Access Compliance Report

Public Rights-of-Way

(Curb Ramps)

Intersection ID: 9694	Main Street: PEACEFUL_WAY_DR	Cross Street: RISING_OAK_DR	Location: W
ADA ID: DEBD5BB4A22A	Ramp Type: BlendTrans1	Initial Pass/Fail: Fail	Overall Compliance: No
Severity Score: 10			
Codes/Mitigation Info/Possible Solution		Field Measurements/Component Compliance

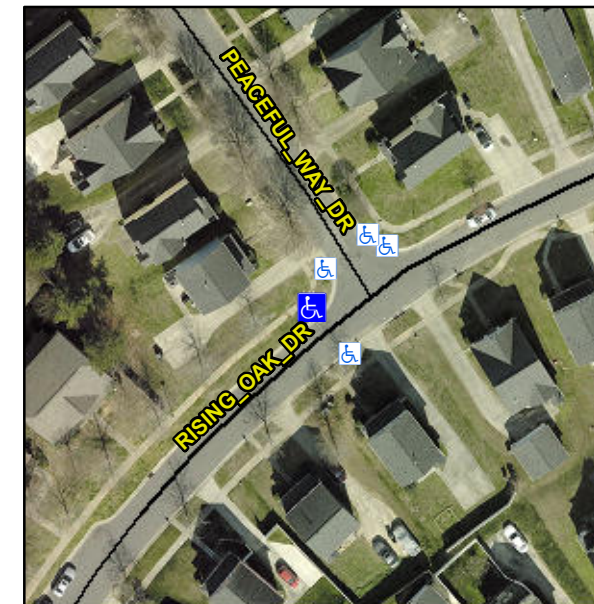
Not Found, R304.5.1, R304.5.3

Compliance	Description	Data	Compliance	Description	Data
N/A	Ramp Length (in)	90.0	Yes	BlendTrans Slope (%)	4.0
No	Ramp Width (in)	45.5	No	BlendTrans XSlope (%)	3.1
N/A	Flare Type LT	N/A	N/A	Flare Type RT	N/A
N/A	Flare Slope LT (%)	N/A	N/A	Flare Slope RT (%)	N/A
N/A	Flare Traversable LT?	N/A	N/A	Flare Traversable RT?	N/A
N/A	Landing Length (in)	N/A	N/A	DWS Provided?	N/A
N/A	Landing Width (in)	N/A	N/A	DWS Contrast?	N/A
N/A	Landing Slope (%)	N/A	N/A	DWS Length (in)	N/A
N/A	Landing X Slope (%)	N/A	N/A	DWS Full Width?	N/A
N/A	Landing Curb? (Y/N)	N/A	N/A	DWS Offset (in)	N/A
N/A	Shared Landing?	N/A			
N/A	Gutter Ponding?	N/A	N/A	Gutter Slope (%)	N/A
N/A	Gutter Lip Ht (in)	N/A	N/A	Gutter X Slope (%)	N/A
N/A	Painted X Walk1?	No	N/A	Painted X Walk2?	N/A
	X Walk 1 Direction	To S		X Walk 2 Direction	N/A
	X Walk 1 Width (in)	N/A		X Walk 2 Width (in)	N/A
	X Walk 1 Slope (%)	2.6		X Walk 2 Slope (%)	N/A
	X Walk 1 X Slope (%)	0.6		X Walk 2 X Slope (%)	N/A

N/A	Ramp inside XWalk1?	N/A	N/A	Ramp inside XWalk2?	N/A
	Road Slope (%)	0.6		Clear Space?	N/A
	Road X Slope (%)	2.6	N/A	Clear Space to XWalk (in)	N/A
N/A	Any Obstructions?	N/A	N/A	Storm Grate/Utility Hazard?	N/A
	Obstruction Type			Storm Grate/Utility Type	
		N/A			N/A
			Yes	Surface Condition? (G/P)	Good
			No	Curb Slope (%)	16.2

Remove & Replace Curb Ramp With Two New Directional Ramps or Equivalent.
